**BEFORE THE BOARD OF PATENT APPEALS
AND INTERFERENCES**

Application Number: 09/658,389
Filing Date: September 08, 2000
Appellant(s): THOMSON ET AL.

EXAMINER'S ANSWER

FIG 1 (Grossly Exaggerated View)

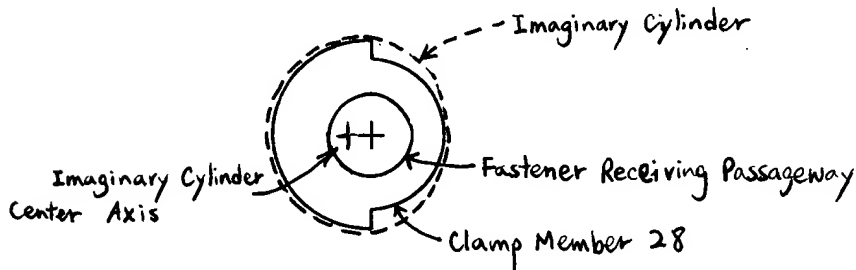
Going back to the appellant’s argument, the appellant asserts that Cheng’s clamp members define “two cylinders, one larger than the other, and each having a passageway aligned with the center axis”, since the clamp members 28 has a reduced diameter portion on one side and an enlarged diameter portion on the other side. The appellant’s assertion may be true, but it is not false to assert that there can be one imaginary cylinder that is defined by an arc portion on the reduced diameter portion and an arc portion on the enlarged diameter portion of Cheng’s clamp members making the imaginary cylinder to look like an “egg-like” oval shaped cylinder. The claim language does not limit the definition of the imaginary cylinder to be defined by the **entire** outer surface of the clamp members, but rather “outer surface **portions**” define the imaginary cylinder. Therefore, it is well within the definition as set forth in the claim language that the oval shaped imaginary cylinder can be defined by the opposite end arc portions which are part of the “outer surface portions” of Cheng’s clamp members. As a result of the imaginary cylinder being an egg-shaped cylinder, the center axis defined by the imaginary cylinder is offset

from the passageway as shown in Fig. 1 below. (Note: the Examiner interpreted the axis defined by the imaginary cylinder of Cheng to be the center axis of the imaginary cylinder so that it would be consistent with the appellant's axis as shown in Fig. 11, although the axis of Cheng could have been positioned anywhere along the imaginary cylinder as broadly interpreted.)

FIG 2

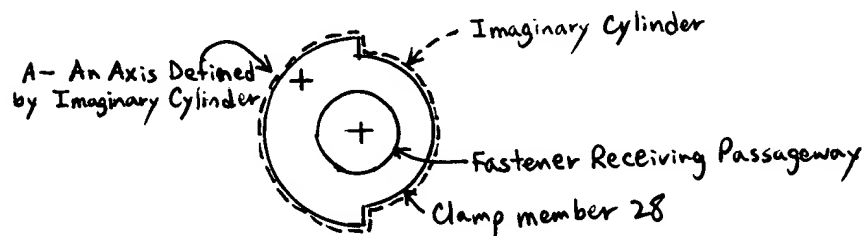
Even if the limitation, "outer surface portions", means the entire outer surface of the clamp members, Cheng's imaginary cylinder can be defined so that the axis of the imaginary cylinder is offset from the passageway. As shown in Fig. 2 below, an axis A, for example, can be positioned offset from the passageway along the imaginary cylinder that is defined by the entire outer surface of the clamp member of Cheng, since the present claim language does not provide specifically how the axis defined by the imaginary cylinder in the present invention is defined.
